| Revision Notes | | | |

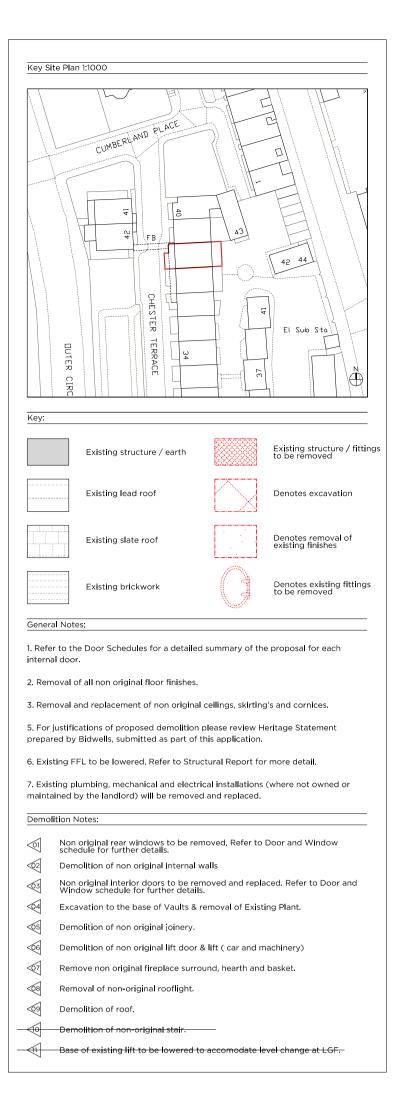
| Revision Notes | | | |
|--|---|--|--|
| | Excavation of vault to depth of existing brick corbels and central trench to allow access to plant equipment. | | |
| B.1 Extent of excavation in vaults rev | rised. | | |
| B.1 Extent of excavation in vaults re- | /ised. | | |
